THE STATE OF NEW HAMPSHIRE
BEFORE THE
NEW HAMPSHIRE SITE EVALUATION COMMITTEE

DOCKET NO. 2024-02

PETITION REQUESTING JURISDICTION AND OVERSIGHT OF
EVERSOURCE PROPOSED X-178 TRANSMISSION LINE
REPLACEMENT PROJECT

**Public Service Company of New Hampshire Responses to
Technical Session Data Requests**

ES VER. 11/2015

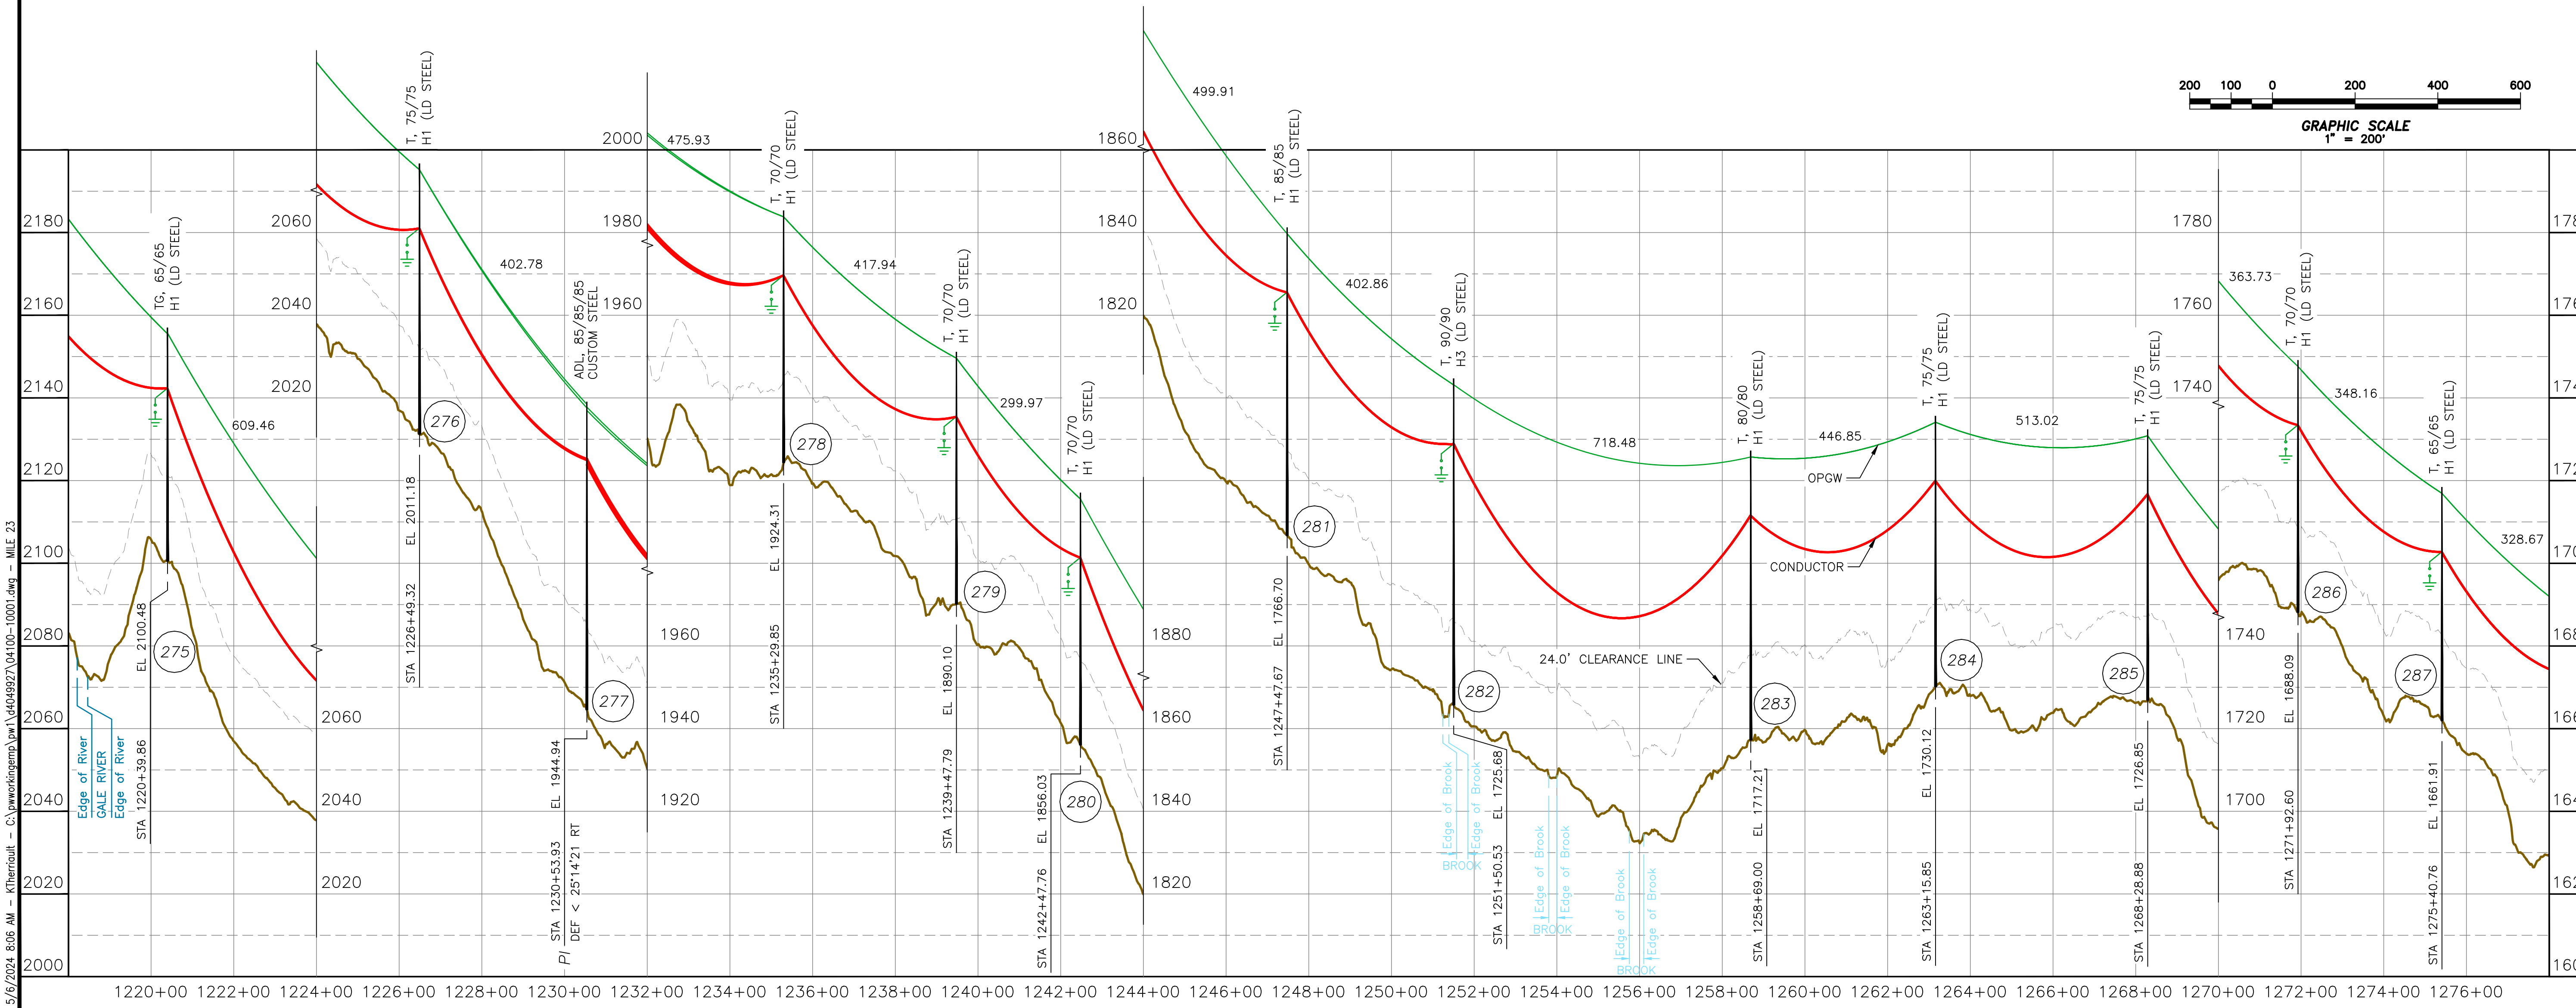
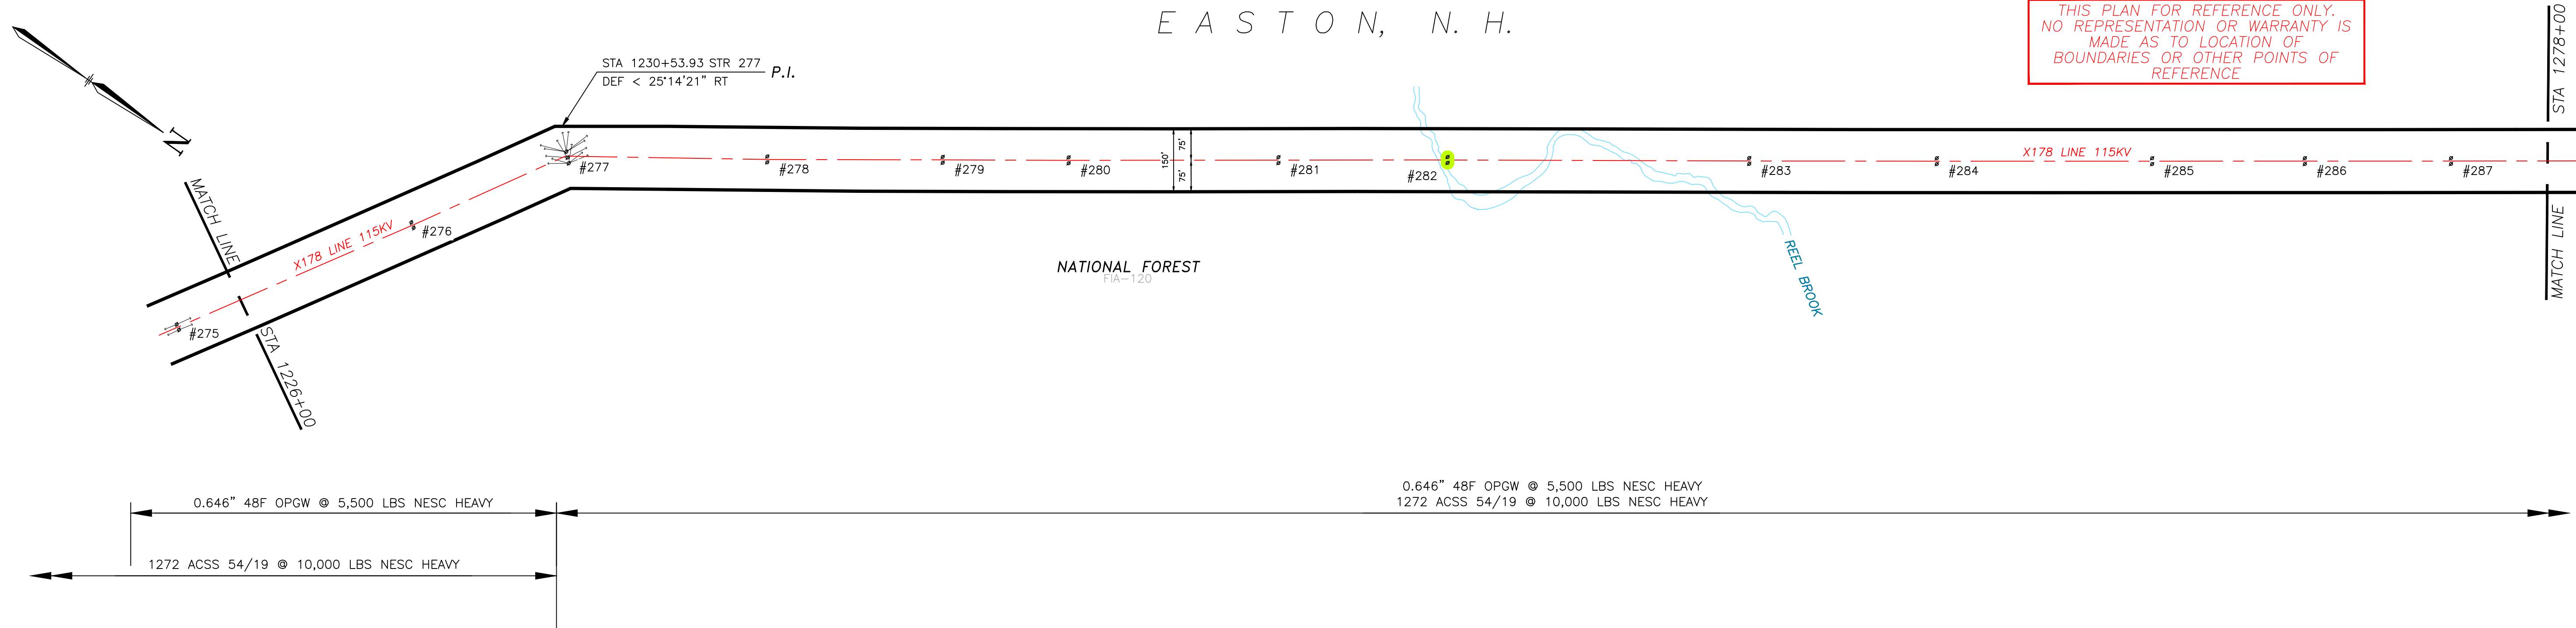
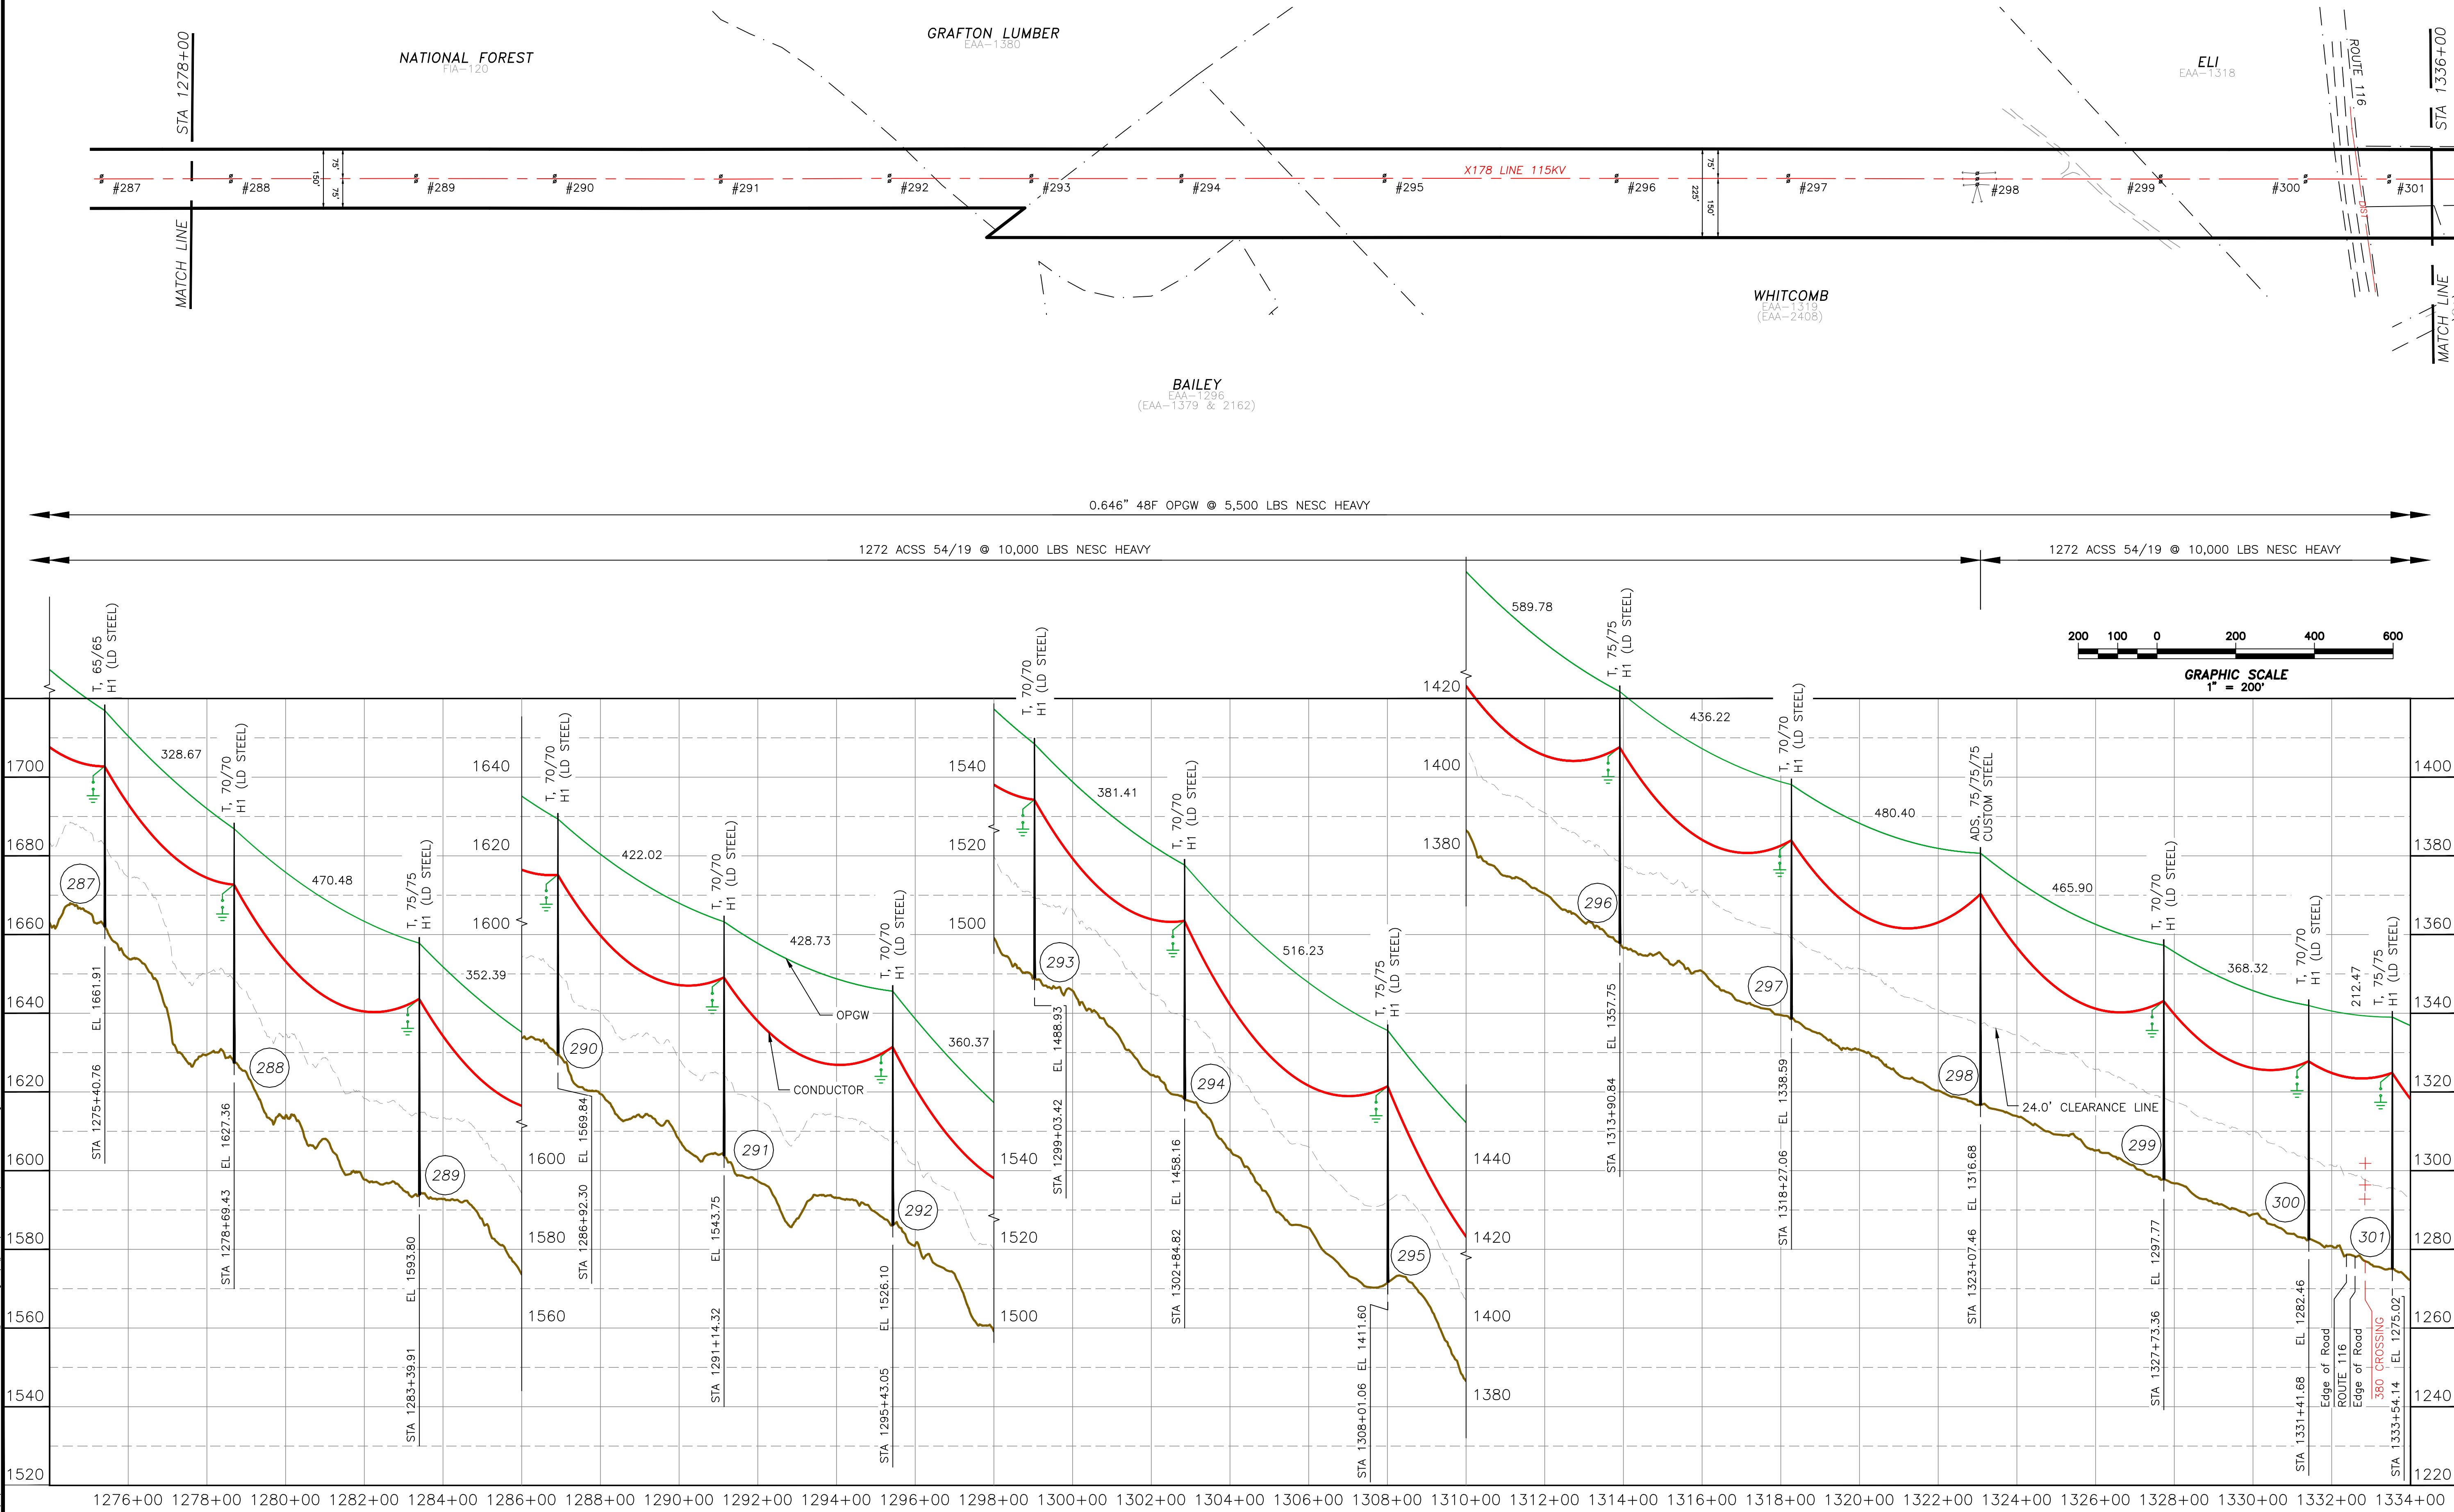
4. Provide profile drawings for the towns of Easton and Bethlehem.

Response: Copies of the profile drawings for the towns of Easton and Bethlehem will be filed as part of the revised Technical Report submitted to the NHSEC. For convenience, the profile drawings are provided to the Town's now as Attachment 1.
